**CALIFORNIA REGIONAL WATER QUALITY CONTROL BOARD
SAN DIEGO REGION**

**PRELIMINARY
TECHNICAL ANALYSIS
SUPPORTING**

**SAN DIEGO UNIFIED SCHOOL DISTRICT
FOR
FAILURE TO COMPLY
WITH**

**ORDER NO. 99-08-DWQ
WASTE DISCHARGE REQUIREMENTS
FOR DISCHARGES OF STORMWATER RUNOFF
ASSOCIATED WITH CONSTRUCTION ACTIVITY
(WDID No. 9 37C329152)**

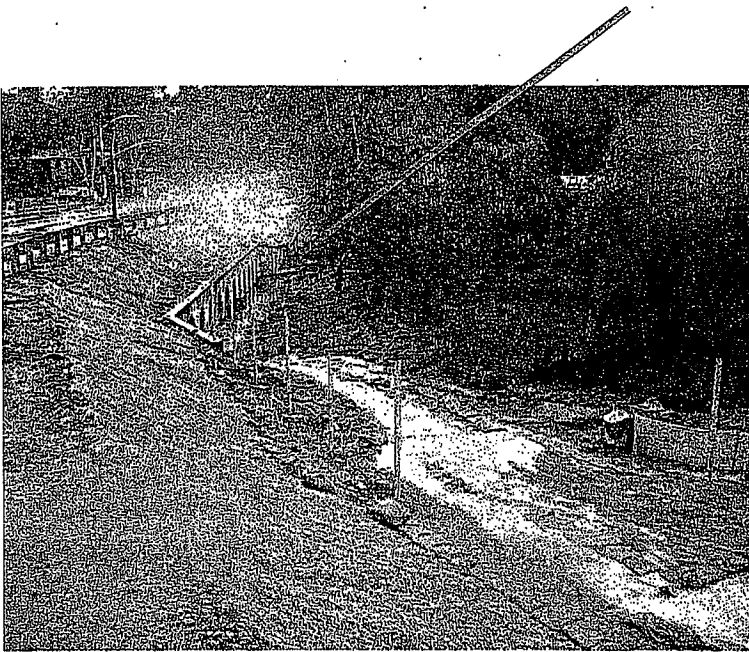
149. Sediment and sediment-laden water entering Carroll Canyon Creek. Arrow points to the culverts for Carroll Canyon Creek going under Avenue of Nations.

150. Photo is looking upstream of the discharge in photo 149. Sediment-laden runoff is flowing from a storm drain culvert outlet pointed out by the arrow.

151. A closer look at the storm drain culvert discharging the sediment-laden runoff.

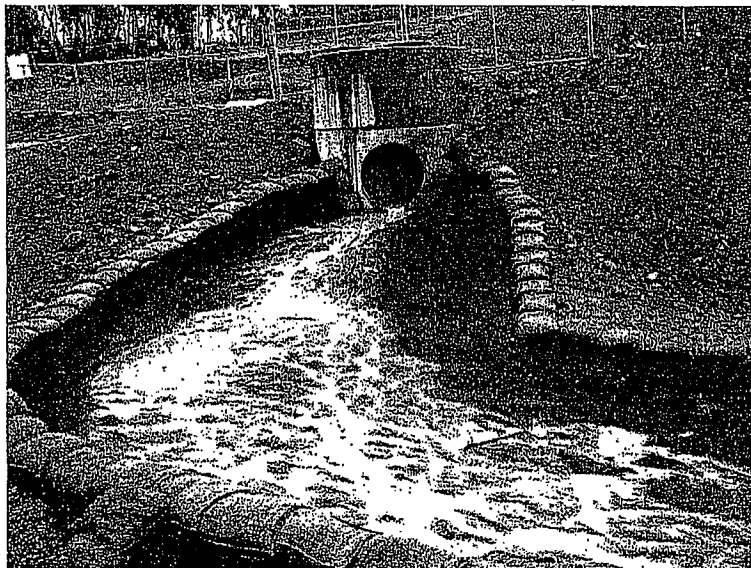
159. Slope failure is causing a discharge of sediment and sediment laden water. Slope face has no fiber rolls.

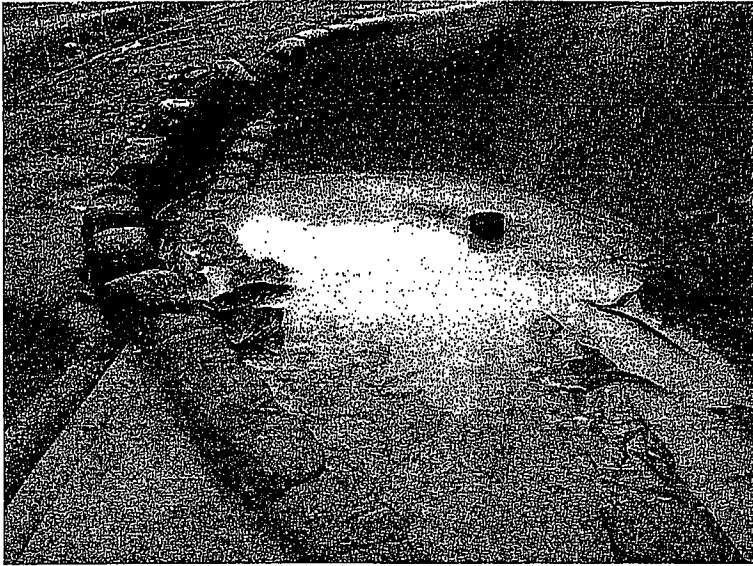
160. Storm drain outfall to the plastic lined ditch along the south side of Avenue of Nations.

163. A storm drain inlet that goes to the discharge point in photo 160. The inlet is overwhelmed with sediment and sediment-laden water.

164. Medians in the school parking lot did not have any sediment controls.

166. Sediment is tracked onto the street. No sediment controls have been implemented behind the curb.

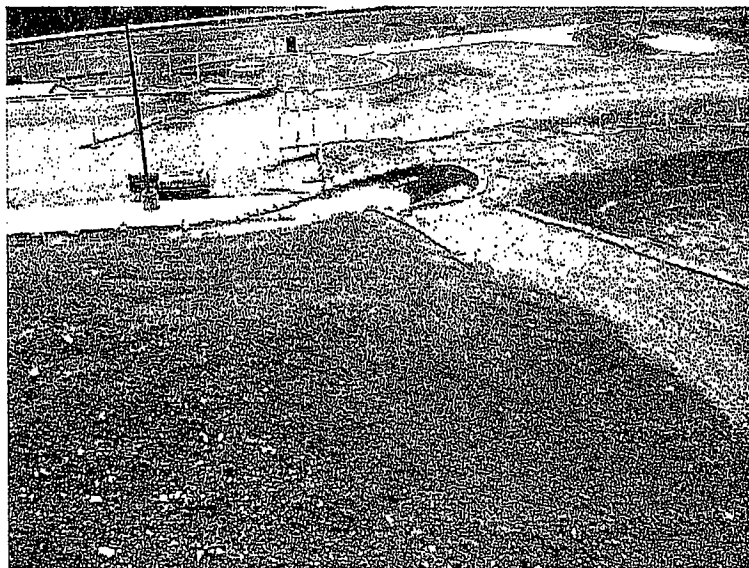
167. Gasoline storage has inadequate cover or containment to minimize storm water exposure.

174. Silt fence around a stockpile is damaged and missing.

176. Looking downhill from the south towards the inlet in photo 163. Inadequate sediment and erosion controls are on the hill.

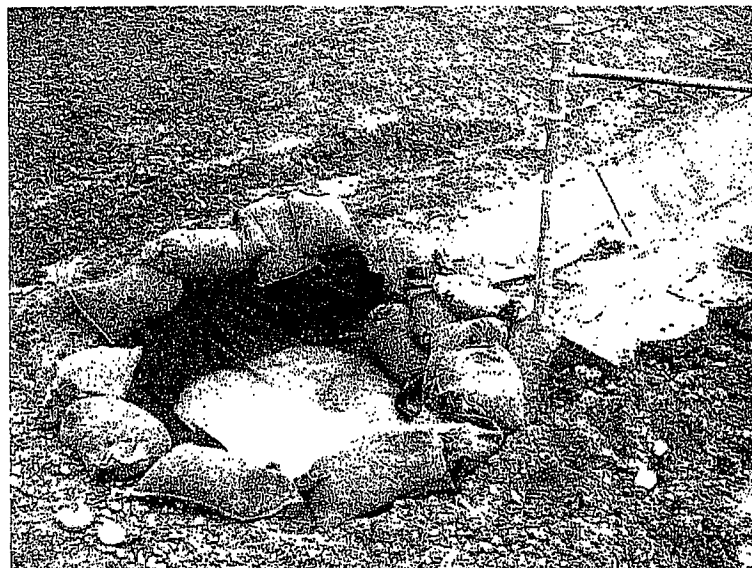
179. Farther uphill than photo 176, but also looking down towards the inlet in photo 163. The arrow points to 2 small rivulets of sediment-laden water running down the access road.

178. Upstream of the inlet in photo 177, the slope has no sediment controls along the toe of slope or in the concrete v-ditch.

177. A storm drain inlet with sediment laden water.

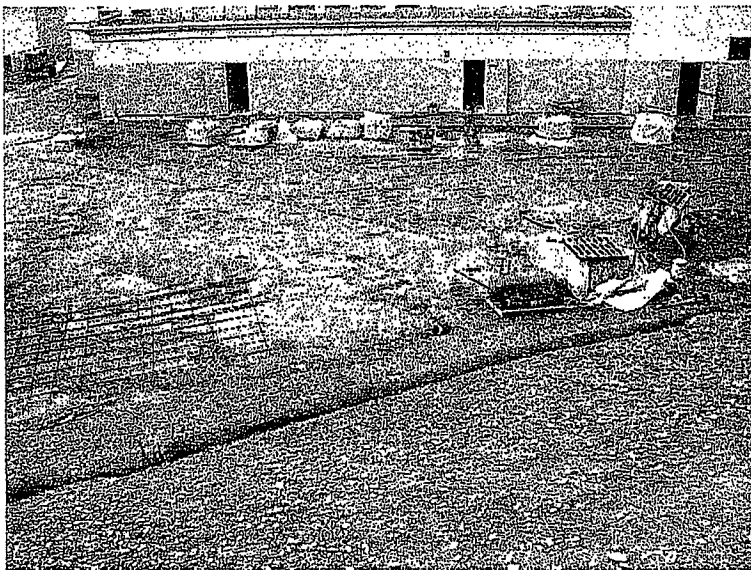
175. Looking uphill to the south from photo 179.

173. Material wash water spills are on the ground.

181. The arrow points to an open bag of concrete mix left out in the rain.

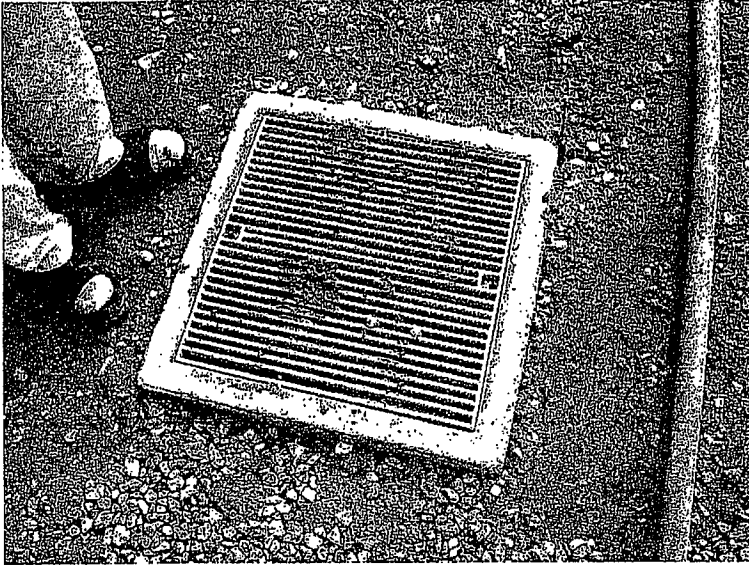
185. Sediment laden water entering a storm drain inlet with inadequate protection.

186. Storm drain inlet has no sediment protections.

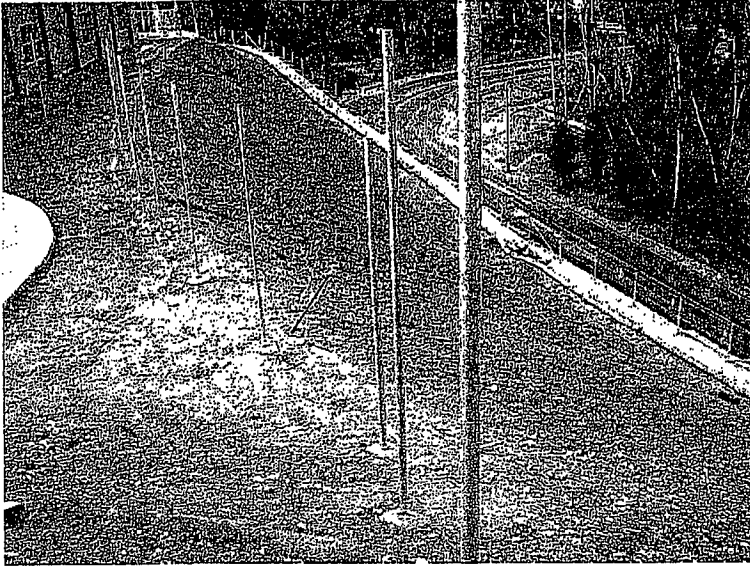
187. Storm drain inlet that is covered with filter fabric and gravel bags has been overwhelmed by sediment flows.

188. A slope with inadequate sediment controls. The fiber roll has failed. An erosion gully is running along the slope next to the wall.

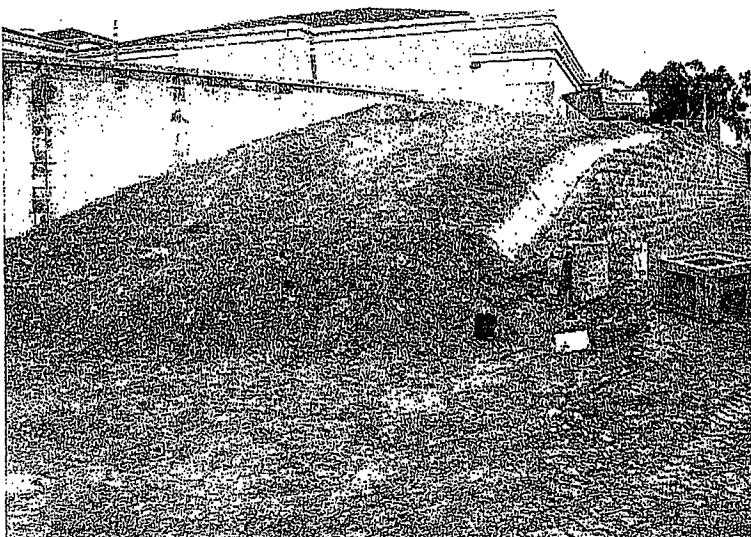
192. A slope has no erosion or sediment controls. A construction access road has no sediment controls.

200. A slope with no erosion or sediment controls.

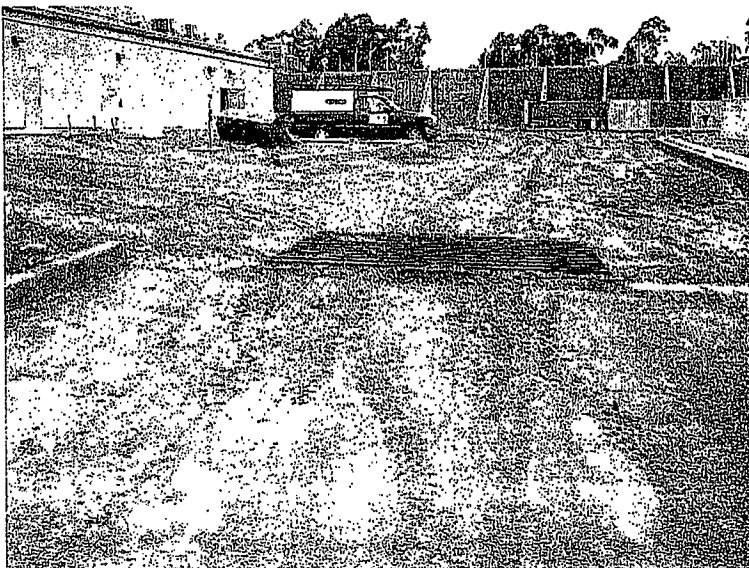
201. A construction access road with no sediment controls.

193. Dirt stockpiled on the street with no controls to minimize contact with runoff.

198. Construction exit has inadequate BMPs to prevent sediment tracking. They have one rumble plate and no gravel. Significant amounts of sediment have been tracked onto the paved surface.
